# Access Compliance Report Public Rights-of-Way (Curb Ramps)

| Main Street: N_ESPLANADE_ST             |                                  | Cross Street: SPRING_ST |                                         | Location:       | NW |
| ADA ID: RPAT210927113410                | Ramp Type:Type 1 - Perpendicular | Initial Pass/Fail: Fail | Overall Compliance: No                  | Severity Score: | 32 |

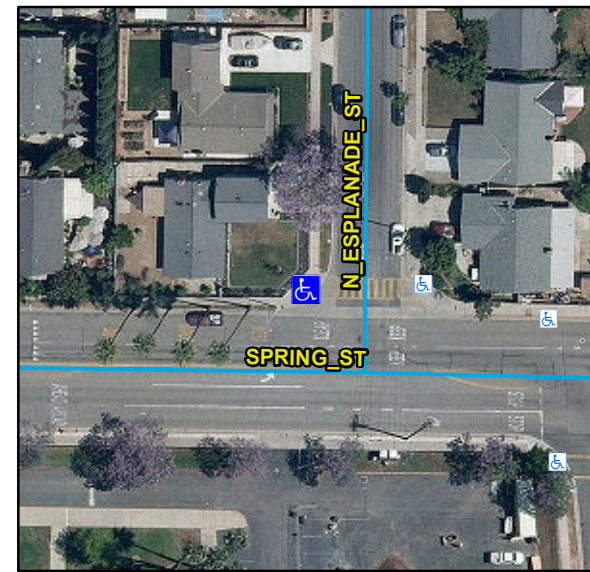
| Compliance | Description                           | Data | Compliance | Description                   | Data |
|------------|---------------------------------------|------|------------|-------------------------------|------|
| No         | Ramp Run Slope (%)                    | 13.7 | N/A        | Flare Slope LT (%)            | N/A  |
| No         | Ramp Cross Slope (%)                  | 4.2  | N/A        | Flare Traversable LT          | N/A  |

**Remove & Replace Entire Ramp. Restripe Crosswalk.**

**R304.2.2, R304.5.3, STD 1115**
